**CBE, Sierra Club, Center, ForestEthics et al. Comments on the Revised Draft
Environmental Impact Report for the Phillips 66 Company Rail Spur Extension and Crude
Unloading Project**

**Attachments to Expert Report of Phyllis Fox on the Revised Draft Environmental Impact
Report for the Phillips 66 Rail Spur Extension and Crude Unloading Project, November
2014.**

Comments
on
Environmental Impact Report
for the
Phillips 66
Rail Spur Extension Project

January 27, 2014

Figure 1
Overall Existing Rodeo Refinery
Block Flow Diagram

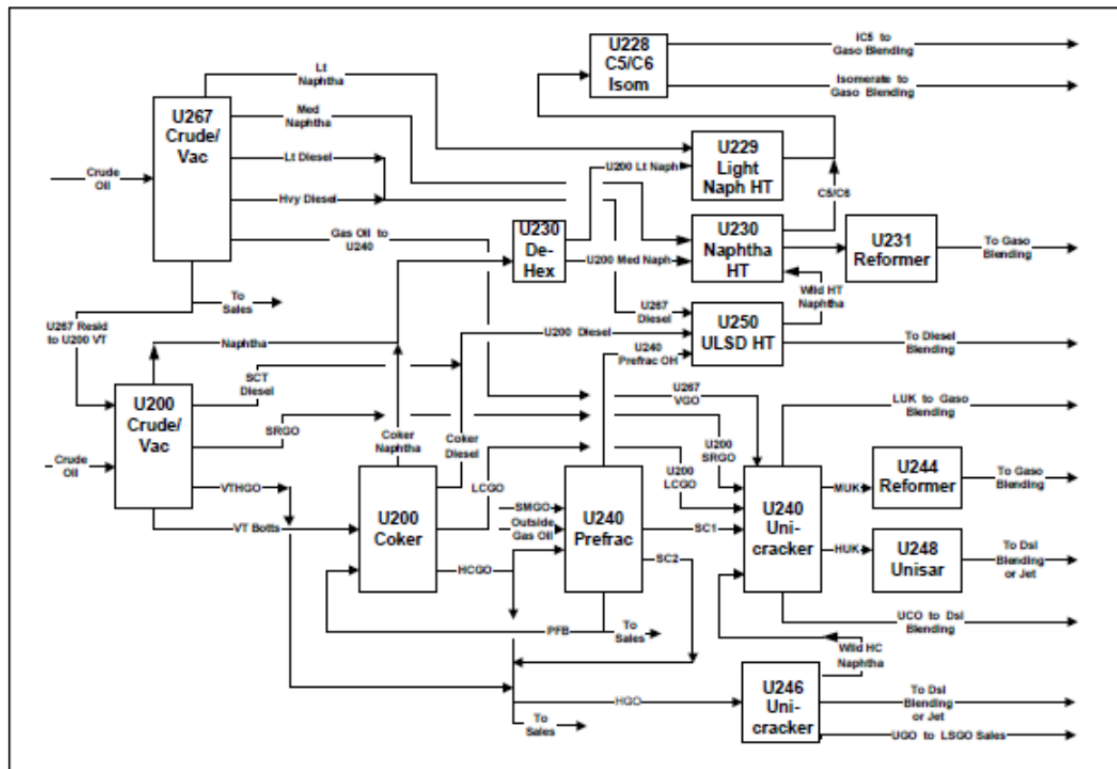
The link between the Santa Maria Refinery semi-refined products (gas oil, naptha) and the Rodeo Propane Recovery Project is clearly shown in the Rodeo Refinery block flow diagrams from the Rodeo Propane Recovery DEIR. The block flow diagram for the existing Rodeo Refinery (Rodeo DEIR Figure 3-4) shows “SMGO” entering the Refinery at the U-240 Prefractionator unit (Prefrac unit). See Rodeo DEIR, p. 3-12 (“Heavy gas oil (HGO) streams from Unit 200 and HGO purchased from outside of the Refinery are fractionated in the Unit 240 prefractionator.”) SMGO is Santa Maria Gas Oil. This Rodeo DEIR figure is reproduced here as Figure 1 for ease of reference. The U-240 Prefrac unit at Rodeo separates Santa Maria gas oil and other gas oils into lighter hydrocarbon fractions that are currently blended into the Rodeo Refinery Fuel Gas, shown in Rodeo DEIR Figure 3-5 (see lower left hand corner, blue arrow labeled U-240/244/248 S-RFG being routed to U-240 Fuel Gas Treating), but which will be further processed into propane and butane in new units added to the Rodeo Refinery as part of the Propane Recovery Project.

Figure 2
Proposed Rodeo Refinery
Fuel Gas System Block Flow Diagram

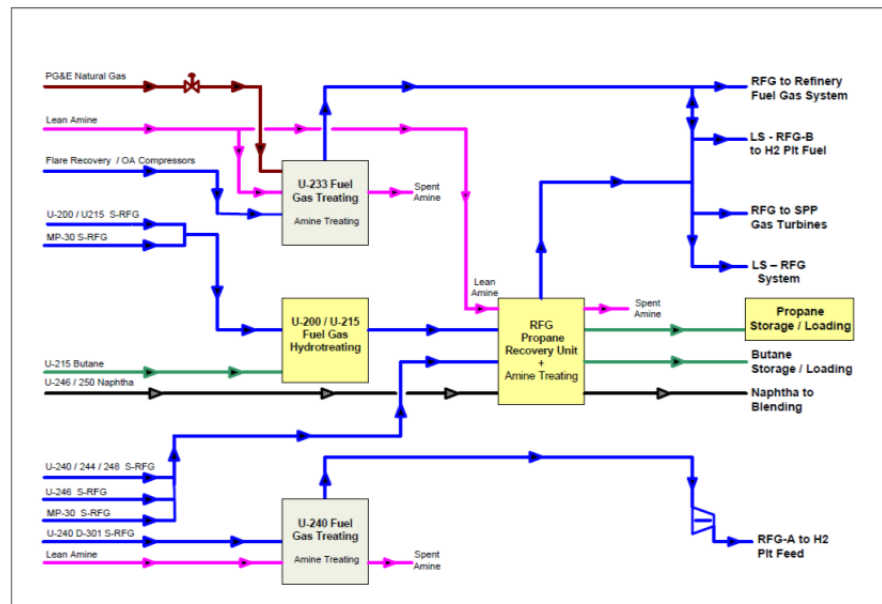
The RFG Propane Recovery Unit is the big yellow box in the middle of Figure 2. Blue arrows in the lower left hand corner of Figure 2 identify the inputs to this unit, which are various refinery streams. These streams include “U-240/244/248 S-RFG.” This designation means that Refinery Fuel Gas (RFG) from Unit U-240 is sent to the RFG Propane Recovery Unit. (This stream was formerly sent to the U-240 Fuel Gas Treating Unit. Rodeo DEIR, Fig. 3-6.) As Santa Maria Gas Oil (SMGO) is one of the inputs to Unit U-240, changes at the Santa Maria Refinery would be transmitted directly to the Propane Recovery Project via the U-240 Prefrac Unit at Rodeo.

This establishes a direct link between the Rodeo Propane Recovery Project and the two modifications at the Santa Maria Refinery -- the Throughput Increase Project and the Rail Spur Project to supply the increase in crude. This is the “nexus” to the larger project with the potential to change crude oil feedstocks.
